A G E N D A

Architectural Review Board

March 22, 2022 – 5:30 p.m.

3010 Cloverdale Road

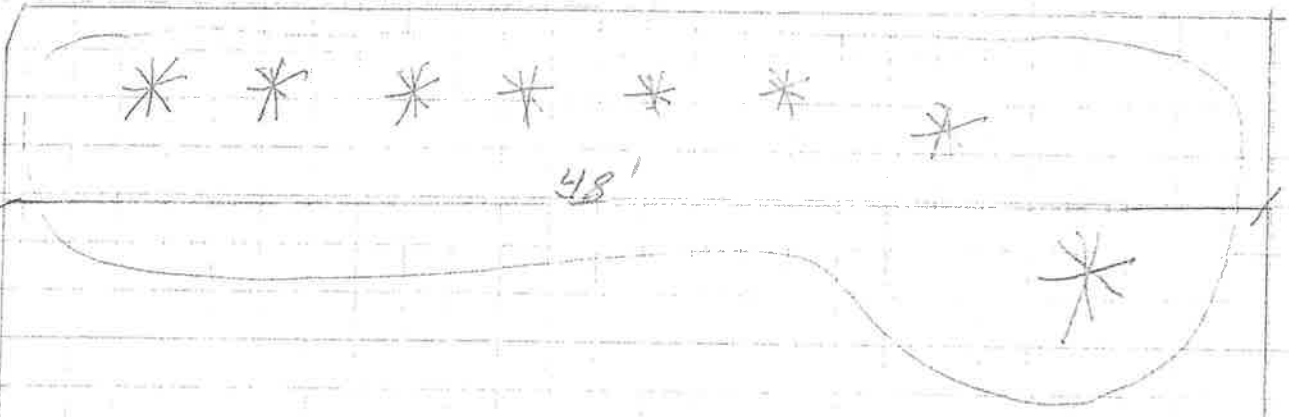
- There is approximately 15’ of right of way in front of this property. The large tree in the front yard is in the city ROW, so the fence encroaches into the City ROW. ARB does not have the authority to grant approval for construction in that location, and the petitioner does not have permission to install fencing off their property.
- Staff recommends the front property line fence be moved behind the trees, running parallel to the street.
- The petitioner needs to insure that the spacing between pickets is equal to or greater than the width of the pickets themselves. Front yard fences taller than 3’ have to be 50% permeable or a variance from the Board of Adjustment will also be required.

Trinity Church Sanctuary Building Front Elevation

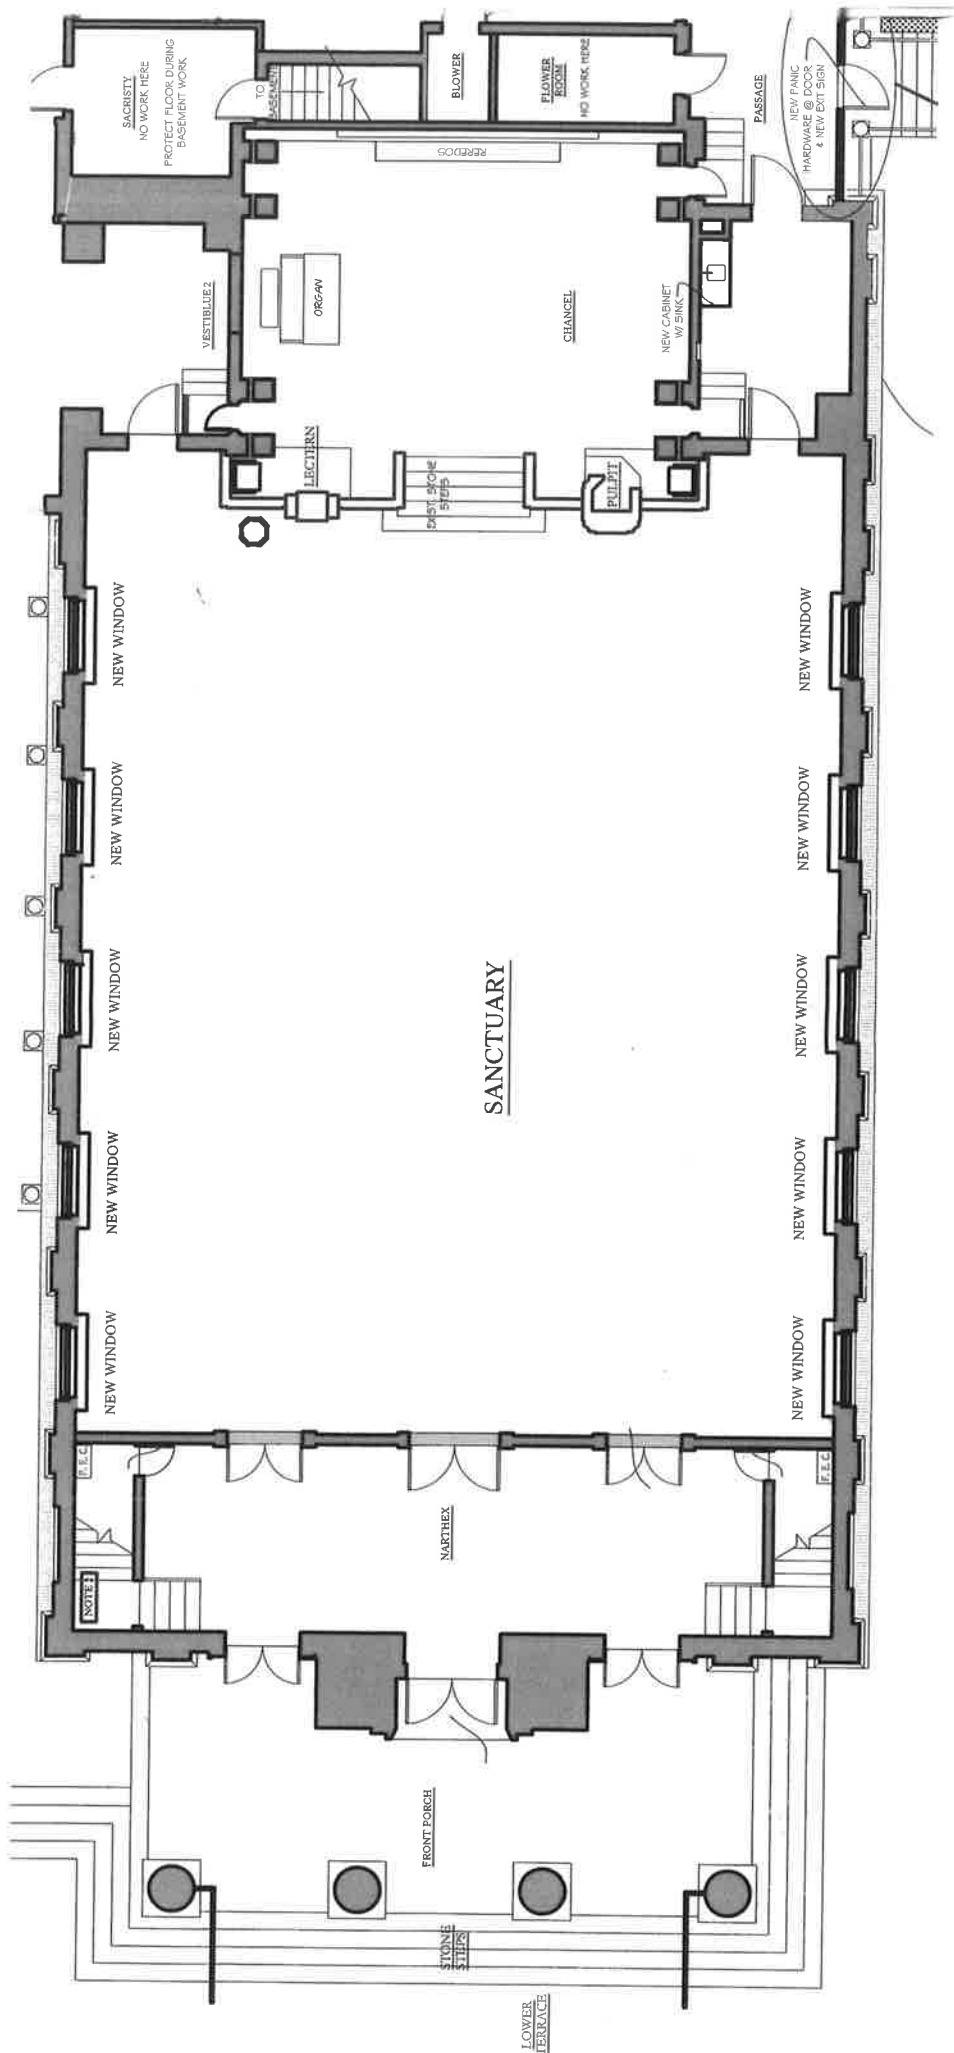
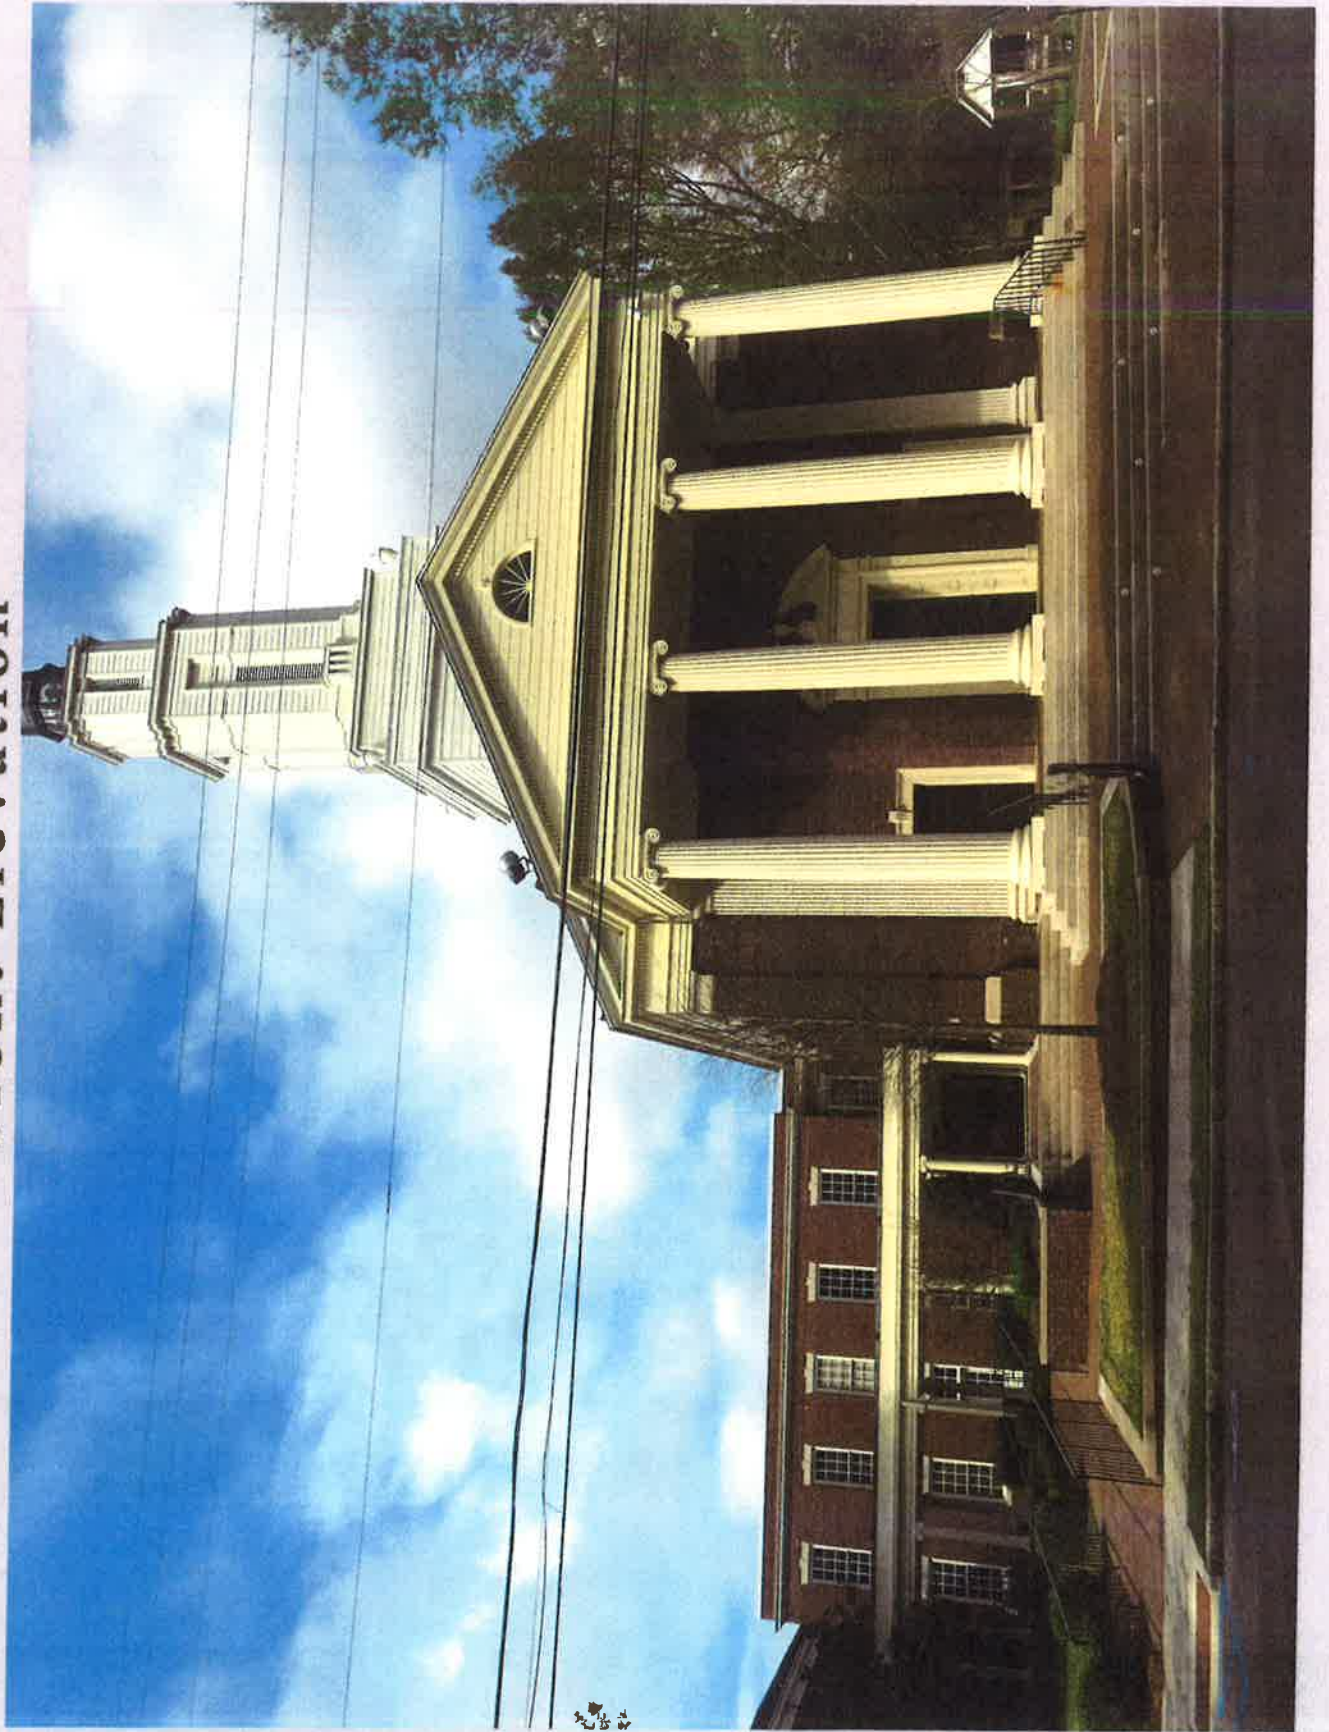
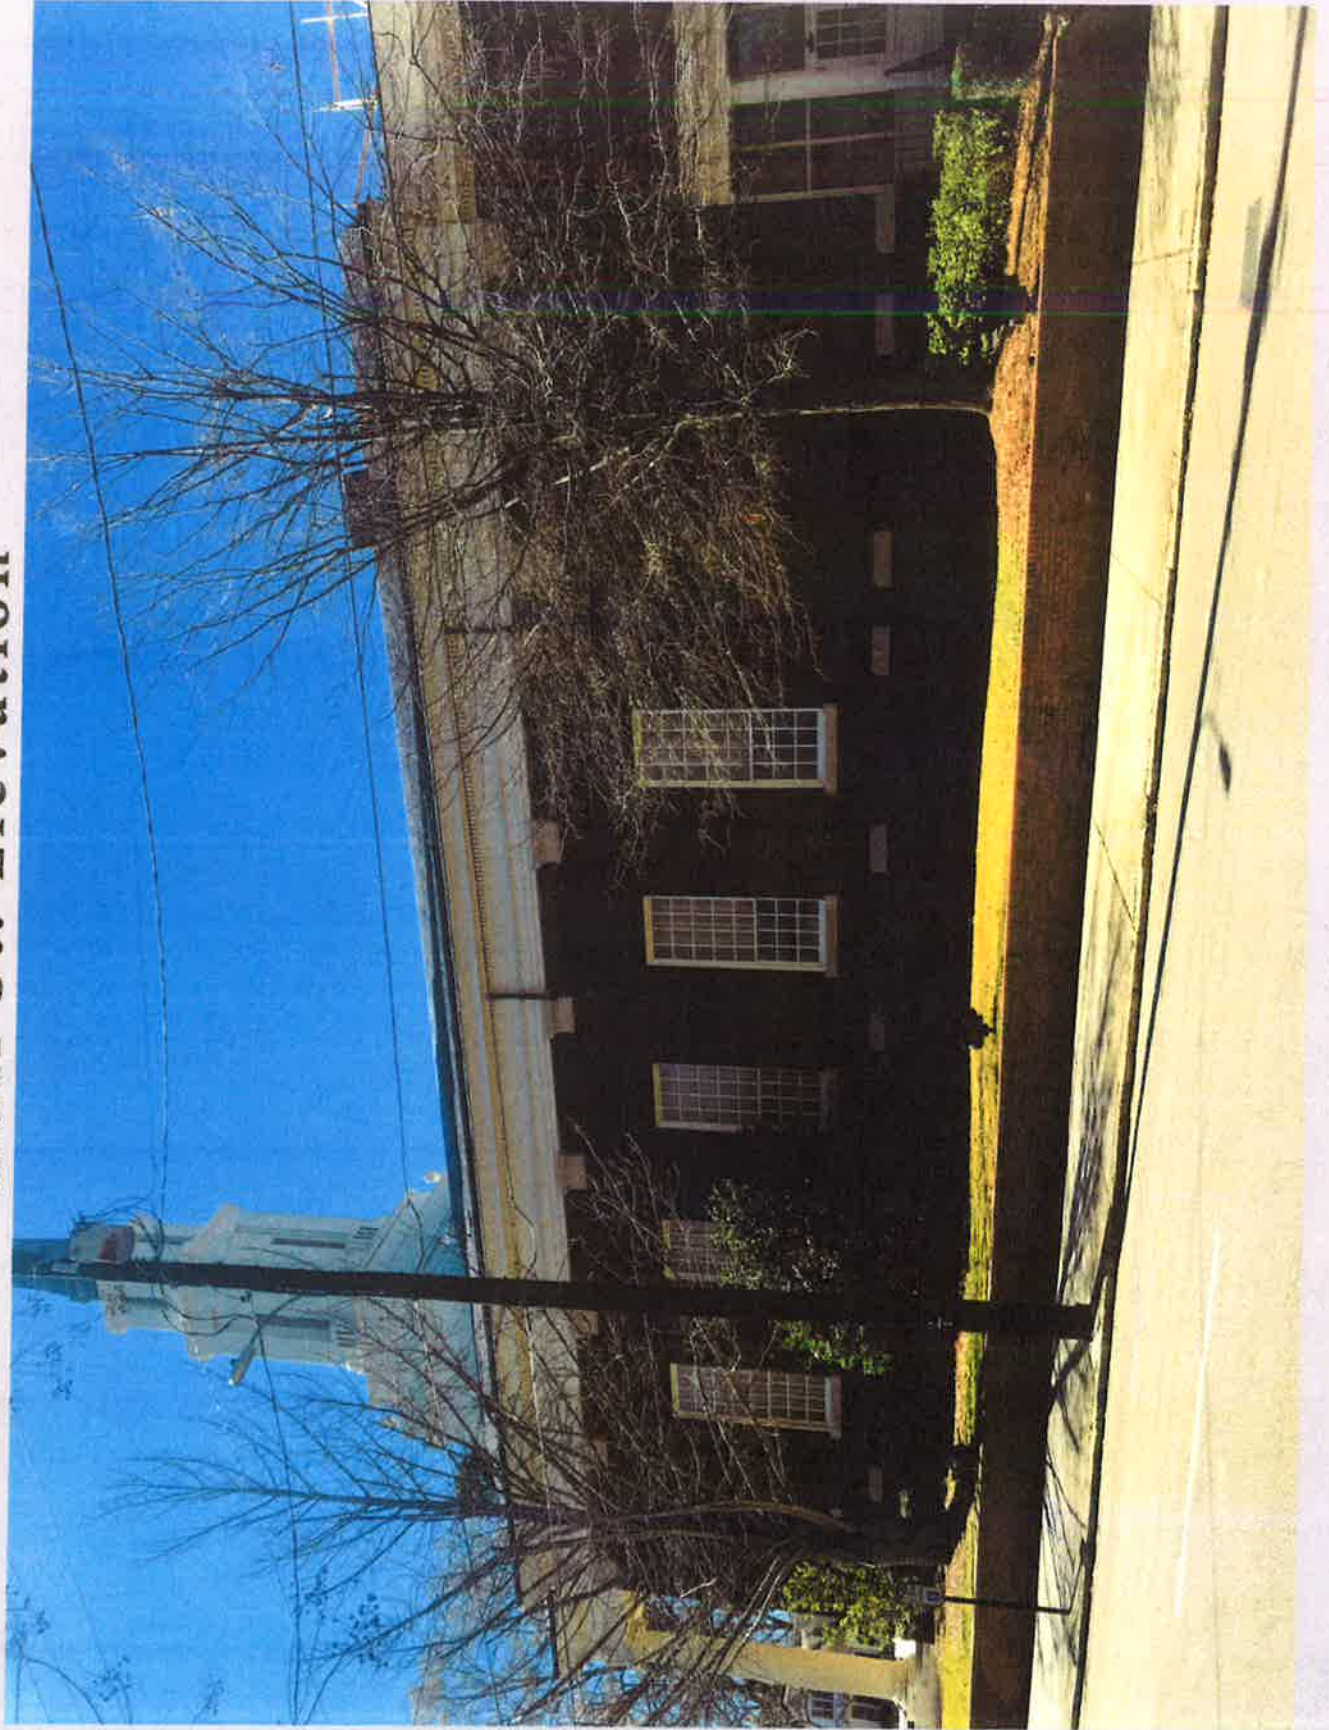
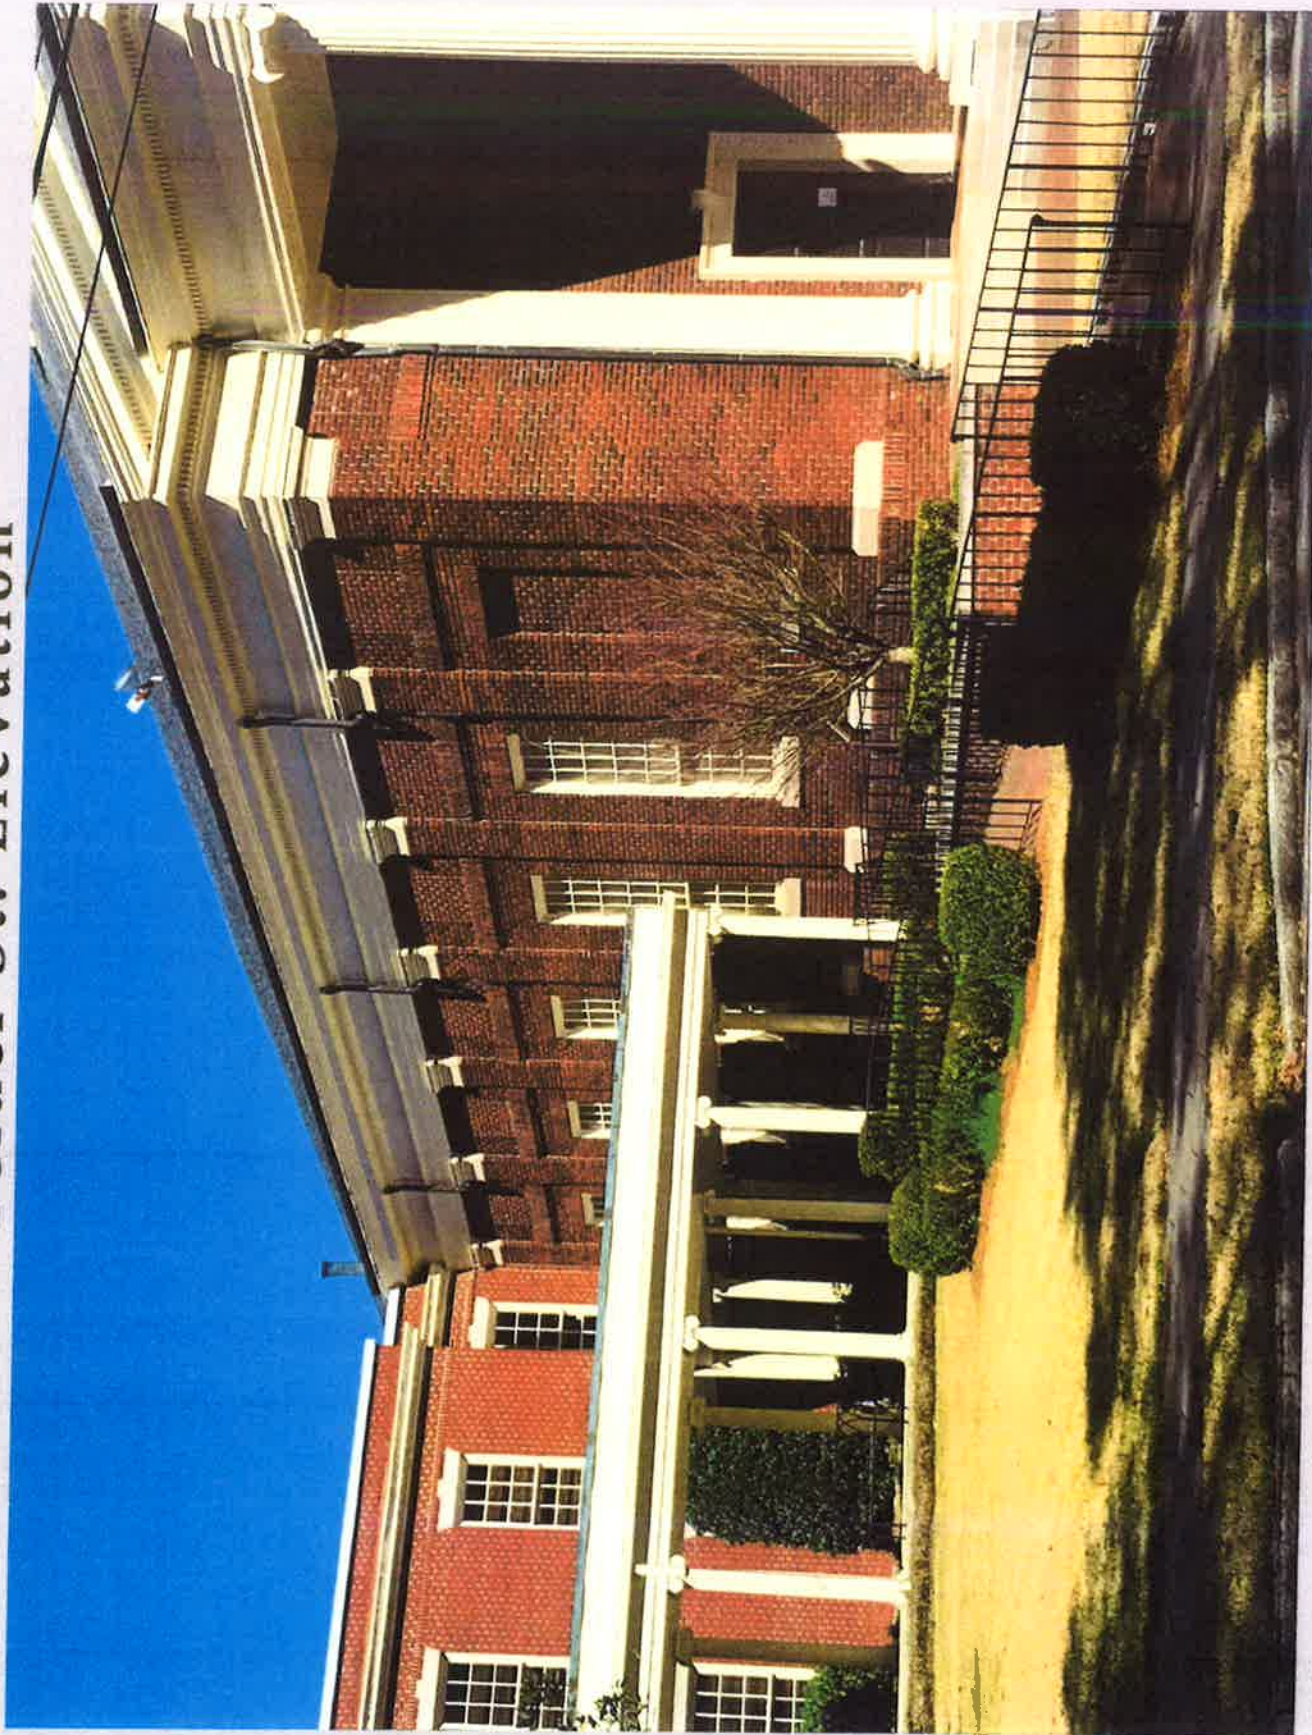
- I have seen the Sierra Pacific windows in Southern Sash’s showroom and remember thinking “that’s a good looking window”, but it is not one that has been brought before the board to date.
